**ASSESSMENT OF SUBSURFACE TRANSPORTER  
SYSTEM FOR THE PROPOSED REPOSITORY AT  
YUCCA MOUNTAIN**

**U.S. Nuclear Regulatory Commission  
Contract NRC-02-02-012**

**Center for Nuclear Waste Regulatory Analyses  
San Antonio, Texas**

**August 2003**

Figure 4-1. Top-Level Fault Tree for Runaway Transporter (CRWMS M&O, 1997b)

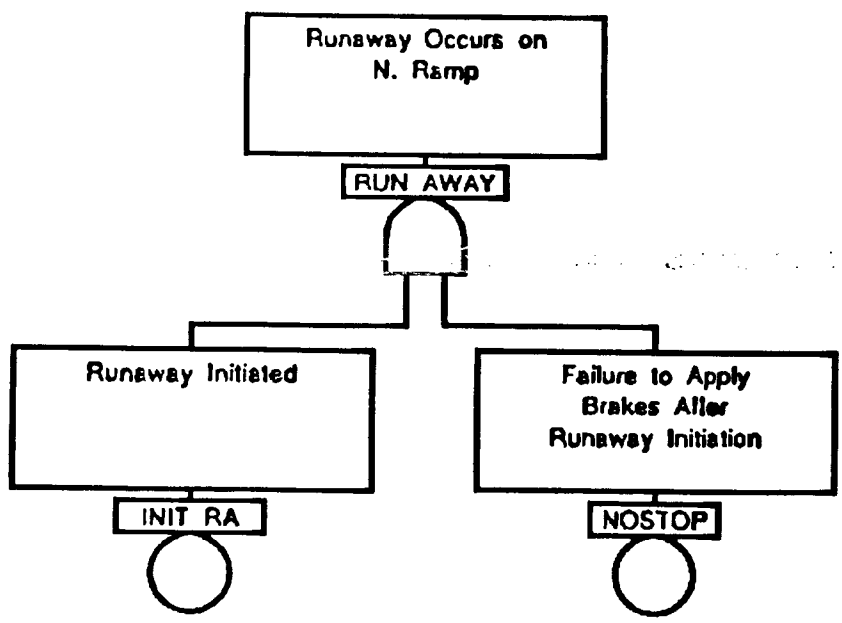
The probability for speed controller initiated runaway is now included in this fault tree, as shown in Figure 4-2, and is "And" gated with the possibility of human operator not responding to this situation from the fault tree analysis. This scenario was evaluated using the SAPHIRE<sup>®</sup> program. The resultant top-level event probability for this fault tree is  $7.30 \times 10^{-9}$  (one order of magnitude greater than the CRWMS M&O probability of  $7.36 \times 10^{-10}$  estimated by CRWMS M&O, 2000). Also, note that the speed control runaway is "And" gated with the probability of the operator failing to respond to a speed alarm, which further lowers the runaway probability. Consequently, staff feel that DOE should look into the possibility that a failure of a speed controller can initiate a runaway event and, therefore, investigate the possibility that it should be "Or" gated instead of "And" gated, as shown in Figure 4-1.

Figure 4-2. Fault Tree Depicting Speed Controller Initiated Runaway Event

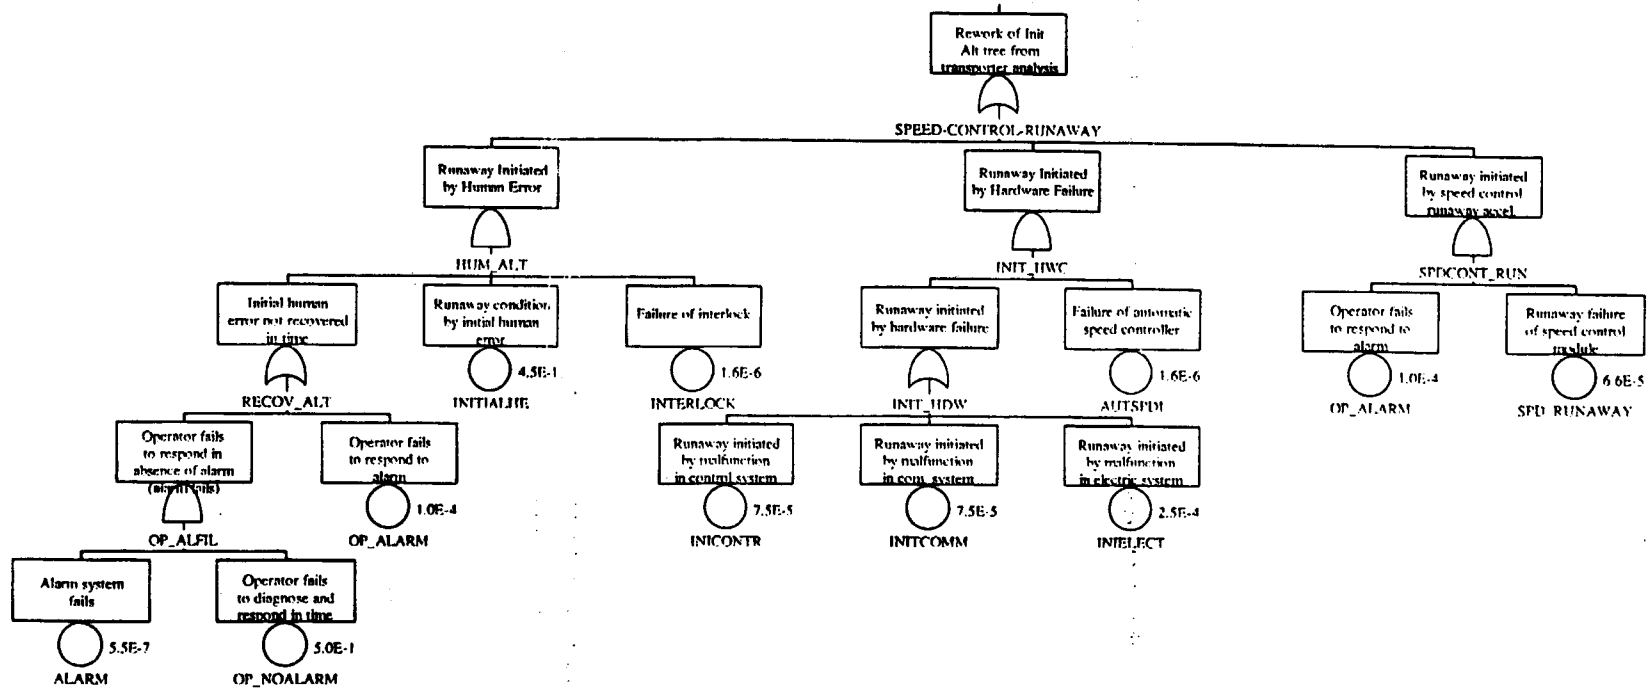
In CRWMS M&O (2000), a runaway event initiated by a hardware failure is "And" gated with a failure of the automatic speed controller. Although staff could not find any data specific to speed controllers for locomotives, automotive accidents have been reported in which the speed controller had initiated a runaway condition, leading to an accident (Anderson, 2003). Staff estimated the probability for a speed control initiated runaway based on a National Highway Traffic Safety Administration study on data collected from 1979 to 1987 for a population of 4.7 million cars and 2,782 accidents caused by sudden cruise-control acceleration during that time period (Anderson, 2003):

Figure 4-3. Revised Fault Tree Showing the Effect of Communication Link Failure

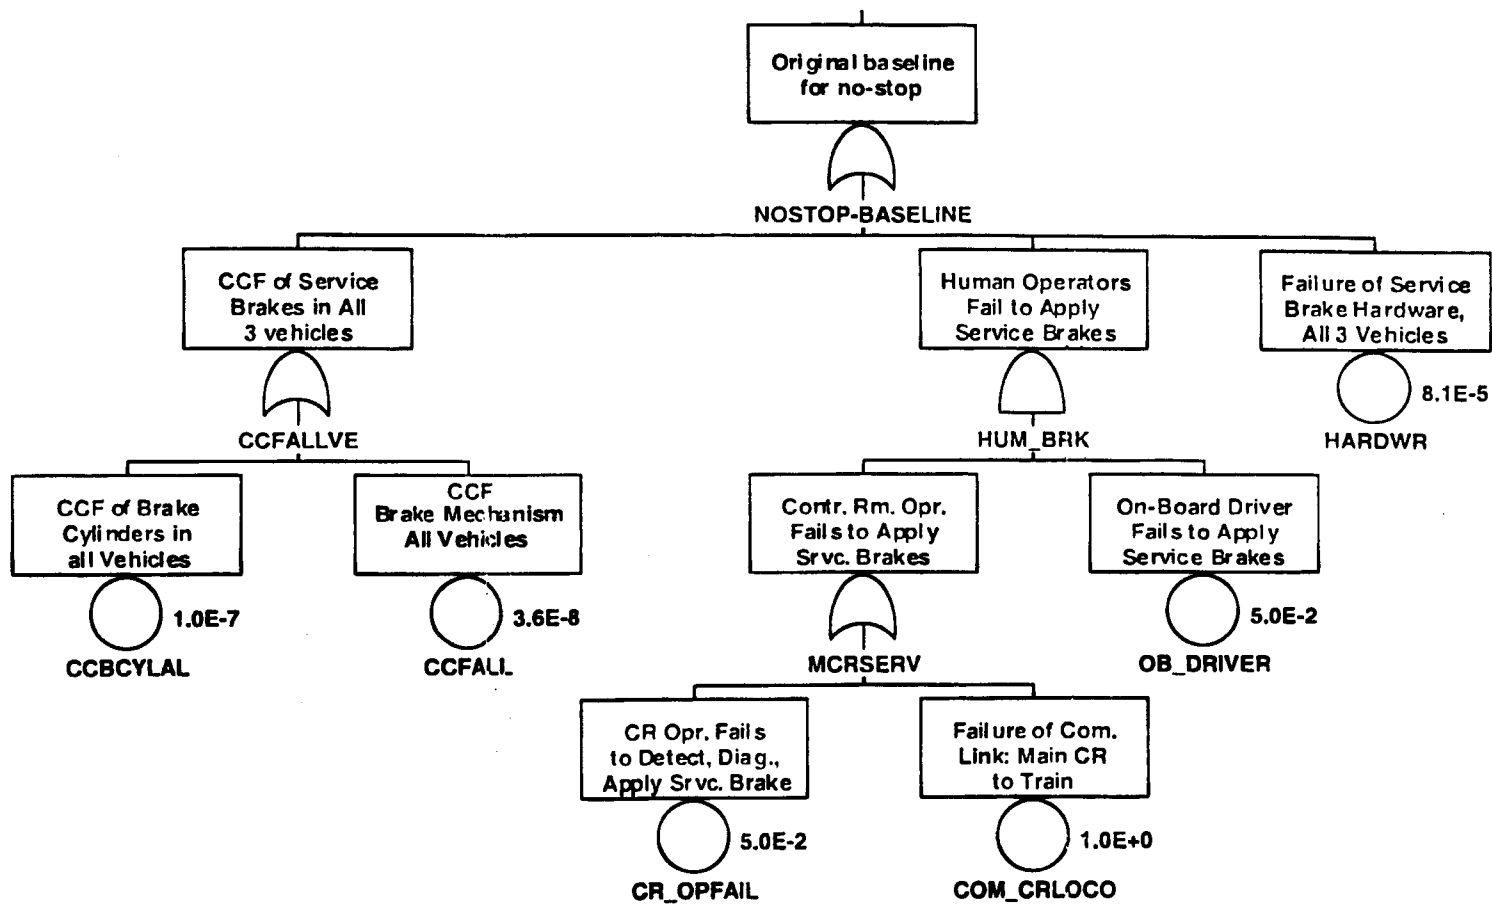
Staff have concerns about the zero probability assigned to a communications link failure event in the "Failure to Apply Brakes After Runaway Initiation" fault tree (CRWMS M&O, 1997a). CRWMS M&O (2000) assumed that the communications link would remain operable throughout the descent because the train would not proceed into the proposed repository unless the communications link was operational at the beginning of the trip. CRWMS M&O (1997a), however, stated that if a spurious signal in the communication system initiated a runaway event ["Runaway Initiated by Malfunction in Communication System" on Page 1 of Attachment I of CRWMS M&O (1997b)], the conditional probability of 1.0 might be appropriate for the "Failure of Communications Link: Main Control Room to Train" event (CRWMS M&O, 1997a). CRWMS M&O (1997a) used a probability of zero for the "Failure of Communications Link: Main Control Room to Train" event in all the analyses. There is a possibility, however, that safety-critical information may be transmitted through the link, either to the operator or directly to one of the safety systems, during descent through the North Ramp. Therefore, the possibility for communications link failure during descent should be considered in the fault tree analysis.

To address the concern about the communications link failure, staff used SAPHIRE<sup>®</sup> software to develop the original "Failure to Apply Brakes After Runaway Initiation" fault tree and confirmed that the top-level failure frequency is  $2.58 \times 10^{-3}$  events per year. Staff conducted another analysis with the failure rate of the communications link changed from 0.0 to 1.0 events per demand because the failure of the communications link could initiate a runaway event by sending spurious communication signals. Results of the staff analysis are given in Table 4-4, and the fault tree is shown in Figure 4-3.

Staff assume a speed alarm and a brake interlock will probably be added to the transporter system as safety features to address the high probability of human initiated runaway. With incorporation of these two features, the probability of a runaway initiation drops from  $2.28 \times 10^{-1}$  to  $4.01 \times 10^{-4}$  events per year. In addition, the probability of the top event, "Runaway Occurs" is now dominated by hardware instead of human failures. Note that the probability for "Failure to Apply Brakes After Runaway Initiation" fault tree increases by one order of magnitude when the communication failure probability is increased to 1.0. Possibility of communication failure during descent increases the overall probability of a runaway event to above the Category 2 level of  $1 \times 10^{-6}$  per year even if an alarm and an interlock are included in the transporter. Therefore, staff conclude that the effects of the failure of the communications link should be considered for further investigation.
